ADDENDUM #1

SUBJECT: Copper River Watershed EVOS Habitat Enhancement Project
 Sites COP 20, 22, 25
 Pre-Bid Meeting Questions and Addendum #1

DATE: January 21, 2021

2
C7 CULVERT STREAM DETAIL
NTS

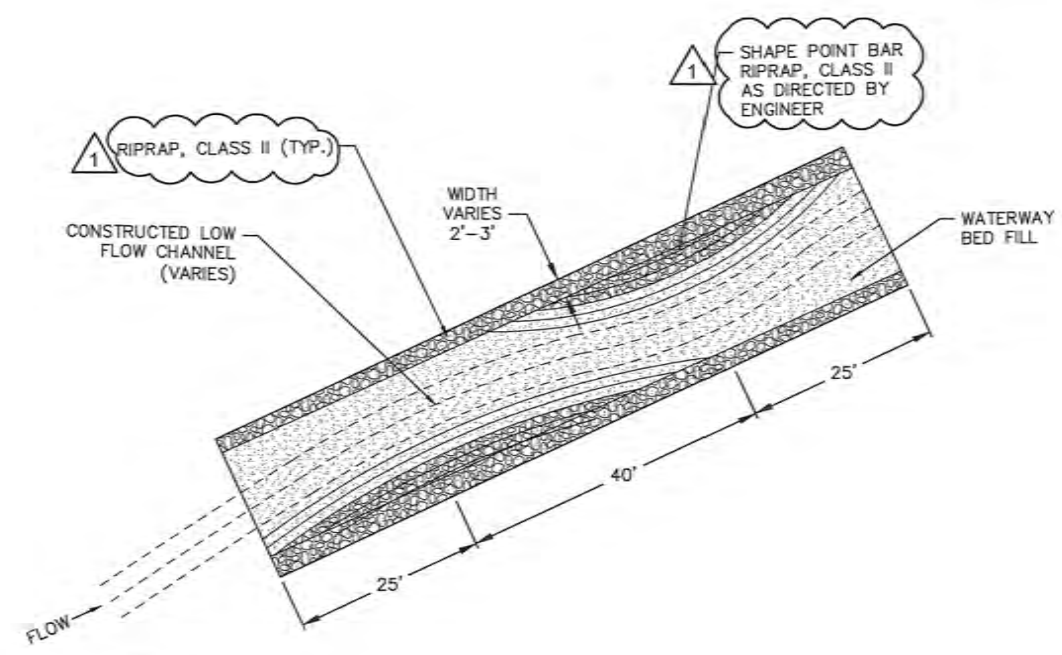
Crossing	Page Numbers	Action	Explanation of Correction
COP 20	C2	<ul style="list-style-type: none"> • Updated Item 611(1A) Riprap, Class I quantity • Deleted Item 690(13) Rounded River Rock • Updated Table 3 Waterway Bed Fill • Deleted Table 4 Rounded River Rock • Deleted Rounded River Rock from Legend 	Question 1
COP 20	C7	Updated labels on Detail 2/C7 from Rounded River Rock to Riprap, Class I	Question 1
COP 20	C8	Updated label on Details 1/C8 and 2/C8 from Rounded River Rock to Riprap, Class I	Question 1
COP 20	C10	Deleted Rounded River Rock from Site Revegetation Legend	Question 1
COP 22	C2	<ul style="list-style-type: none"> • Updated Item 611(1B) Riprap, Class II quantity • Deleted Item 690(13) Rounded River Rock • Updated Table 3 Waterway Bed Fill • Deleted Table 4 Rounded River Rock • Deleted Rounded River Rock from Legend 	Question 1
COP 22	C7	<ul style="list-style-type: none"> • Updated labels on Detail 2/C7 from Rounded River Rock to Riprap, Class II 	Question 1

1
C8
TYPICAL CULVERT SECTION
NTS

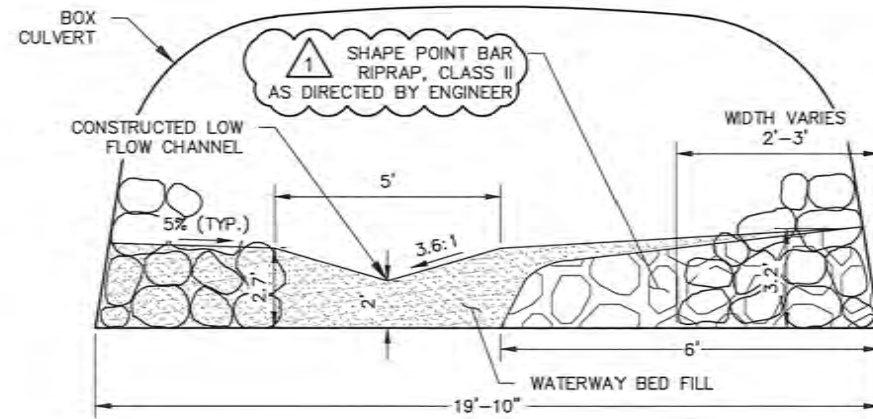
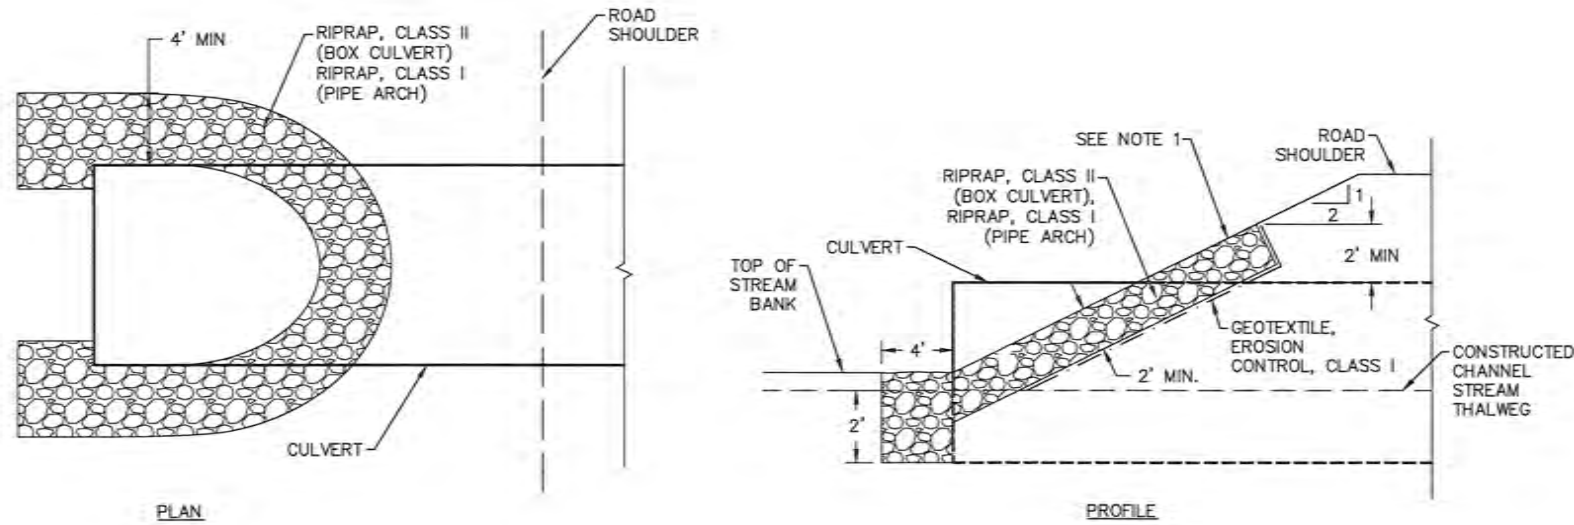
COP 22	C8	<ul style="list-style-type: none"> • Updated label on Details 1/C8 and 2/C8 from Rounded River Rock to Riprap, Class II 	Question 1
COP 22	C10	<ul style="list-style-type: none"> • Deleted Rounded River Rock from Site Revegetation Legend 	Question 1
COP 25	C2	<ul style="list-style-type: none"> • Updated Item 611(1B) Riprap, Class II quantity • Deleted Item 690(13) Rounded River Rock • Updated Table 3 Waterway Bed Fill • Deleted Table 4 Rounded River Rock • Deleted Rounded River Rock from Legend 	Question 1
COP 25	C8	Updated labels on Detail 2/C7 from Rounded River Rock to Riprap, Class II	Question 1

1
C9
TYPICAL CULVERT SECTION
NTS

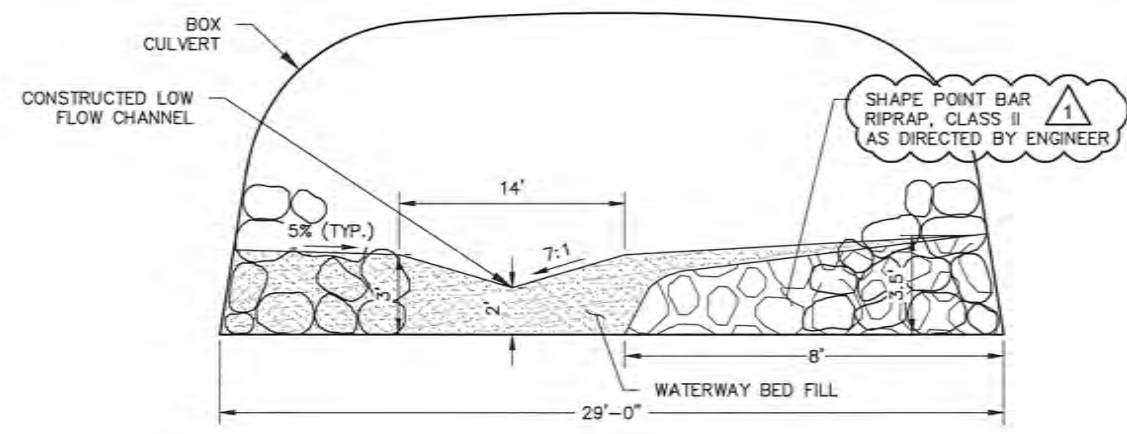
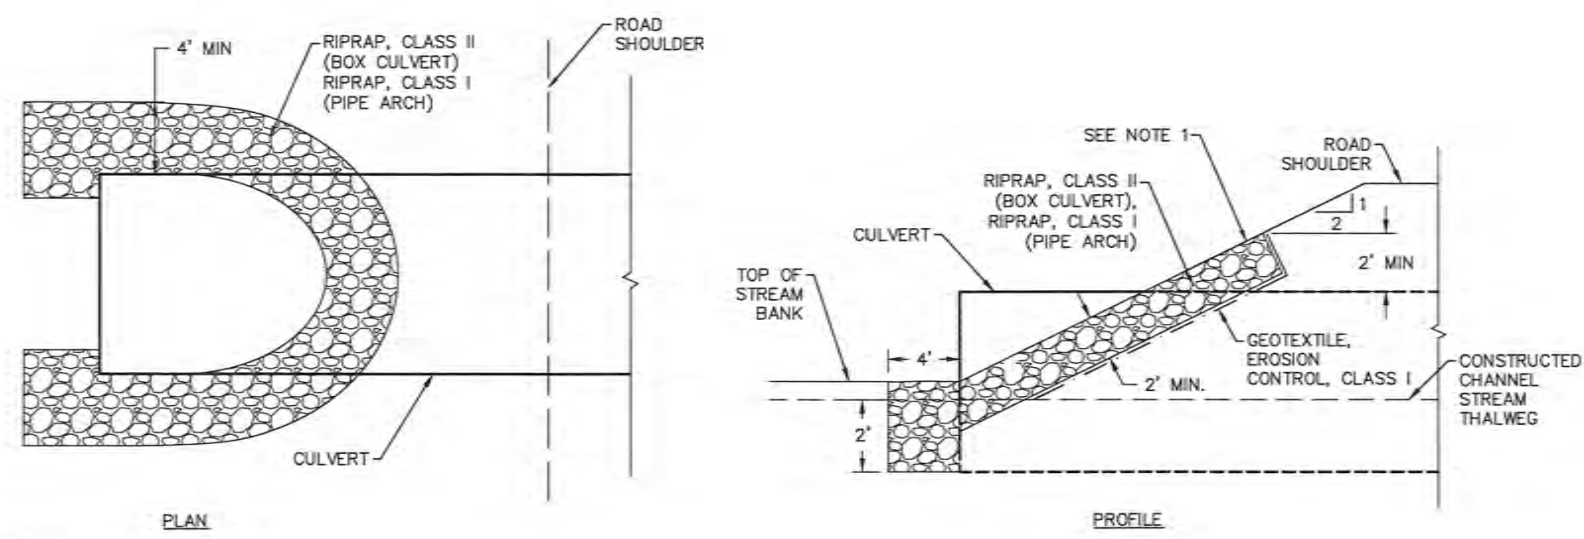
COP 25	C9	Updated label on Details 1/C8 and 2/C8 from Rounded River Rock to Riprap, Class II	Question 1
COP 25	C11	Deleted Rounded River Rock from Site Revegetation Legend	Question 1
